FLASK WALK NEIGHBOURHOOD ASSOCIATION Hampstead London NW3

**Objection re: 71b Flask Walk – Planning Application Number 2022/1289/P**

73 roof terrace – looking towards 71B and proposed site for air con unit

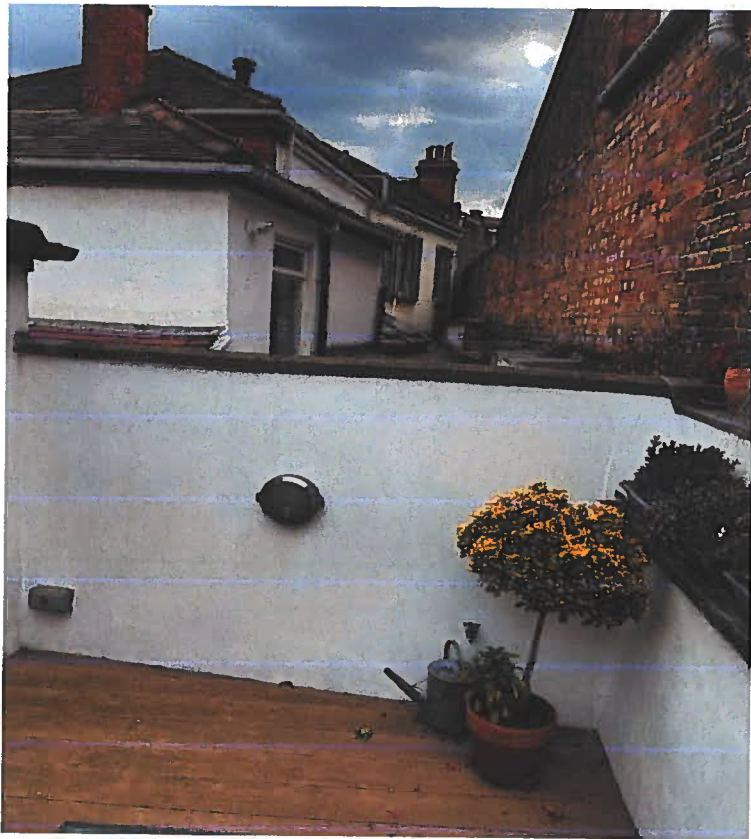
As viewed from Flask Walk, number 73 FW lies to the right of the application property as can be seen from fig 1 of the applicant's Acoustic Report. To the rear of 73 FW is a first-floor roof terrace immediately adjacent to the single storey rear extension of 71B where it is proposed to site the air conditioning unit.

The living room of 73 has full width folding glass door opening onto the terrace. Photographs provided to FWNA by the owner of 73 are attached.

The proposed unit would constitute a serious visual intrusion to those using 73's rear terrace and living room. The D&A Statement suggests that "the external plant has been sited at the rear of the property in an enclosed courtyard surrounded by solid brick walls that is not overlooked by neighbouring properties".

In fact, it would be so close to the top of the wall as to make little difference and when built out may be visible over the wall. Fig 1 of the applicant's Acoustic Report refers to "proposed plant location on roof of proposed additional story (sic)". Is there going to be another storey added to the rear of No.71B?

The constant low-level humming from the unit would be intrusive to the users of the terrace. We note that all noise calculations are based on a location representative of the noise environment at the most affected neighbouring residential windows which are to the left of the application property: see fig 1 of the applicant's Acoustic Report. If this is the most affected, it is one of the more remote locations on the photo. No attempt has been made to calculate the noise that would affect 73's rear terrace which is adjacent. Moreover, we note, even using the applicant's own figures:

- (d) However, the attenuation assumes "propagation losses" of 17dB due to "Hemispherical spreading over 7m to rear windows of neighbouring property". Such losses would not be applicable in respect of a receptor on 73's rear terrace. Note that hemispherical spreading would not be appropriate to the confined acoustics at the rear of No.73.

- (e) The calculated noise levels pertaining at the rear terrace of 73 must be provided before Camden even considers this application.
